Re: 2839636
SUMMIT/WOODSIDE RIDGE #26/MO

Pages or sheets covered by this seal: I50687727 thru I50687728

Job	Truss	Truss Type	Qty	Ply	SUMMIT/WOODSIDE RIDGE #26/MO	150687727
2839636	B5	Hip	1	1	Job Reference (optional)

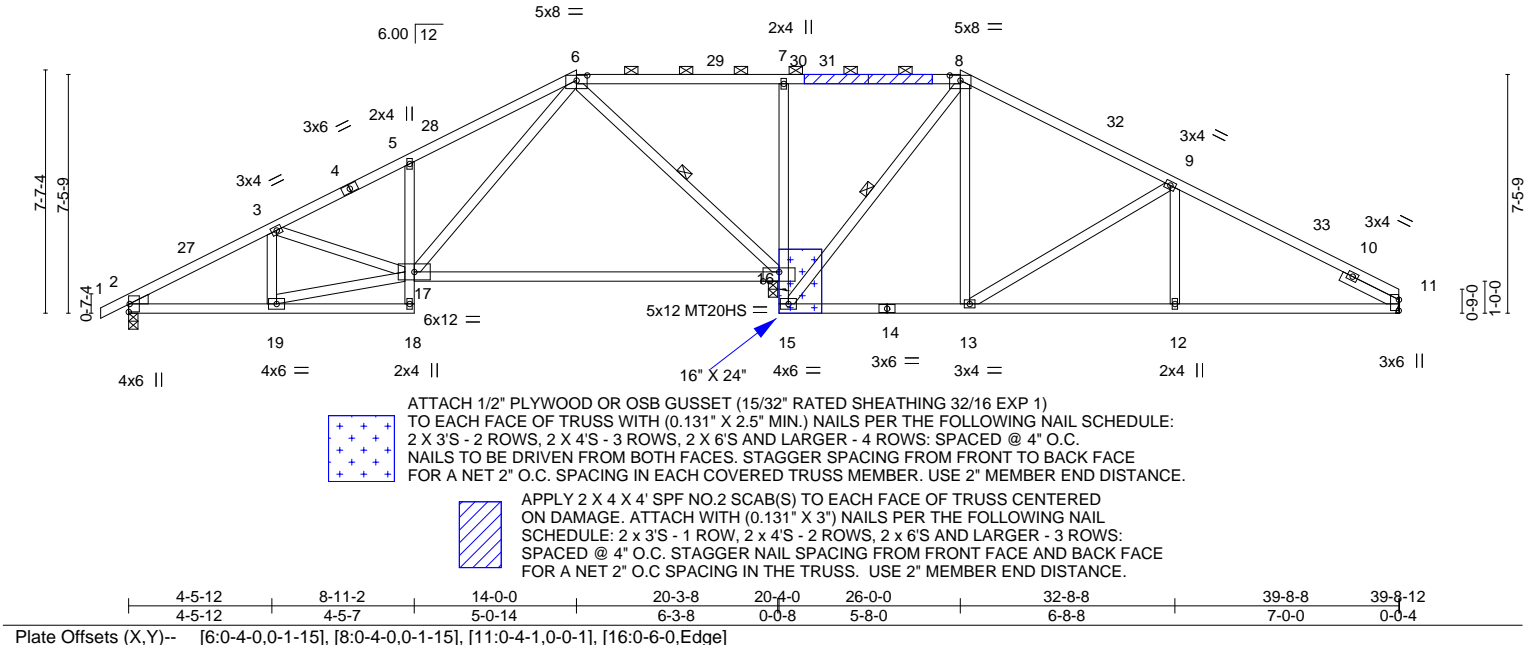
REPAIR: TOP CHORD BROKEN MIDPANEL 7-8
MEMBER 7-15 BROKEN MIDPANEL 15-16

Job	Truss	Truss Type	Qty	Ply	SUMMIT/WOODSIDE RIDGE #26/MO	150687728
2839636	B6	Hip	1	1	Job Reference (optional)

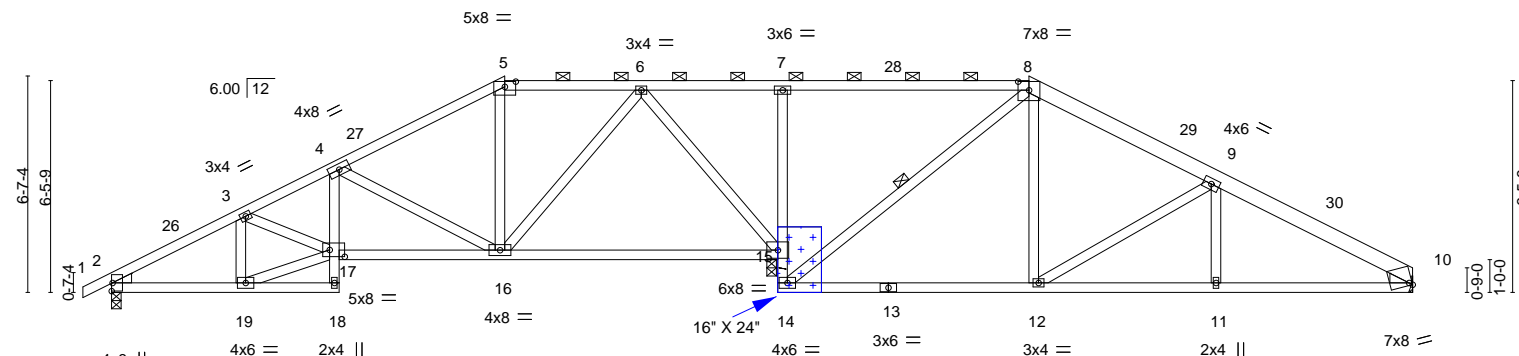
REPAIR: MEMBER 7-14 BROKEN MIDPANEL 14-15

ATTACH 1/2" PLYWOOD OR OSB GUSSET (15/32" RATED SHEATHING 32/16 EXP 1)
TO EACH FACE OF TRUSS WITH (0.131" X 2.5" MIN.) NAILS PER THE FOLLOWING NAIL SCHEDULE:
2 X 3'S - 2 ROWS, 2 X 4'S - 3 ROWS, 2 X 6'S AND LARGER - 4 ROWS: SPACED @ 4" O.C.
NAILS TO BE DRIVEN FROM BOTH FACES. STAGGER SPACING FROM FRONT TO BACK FACE
FOR A NET 2" O.C. SPACING IN EACH COVERED TRUSS MEMBER. USE 2" MEMBER END DISTANCE.
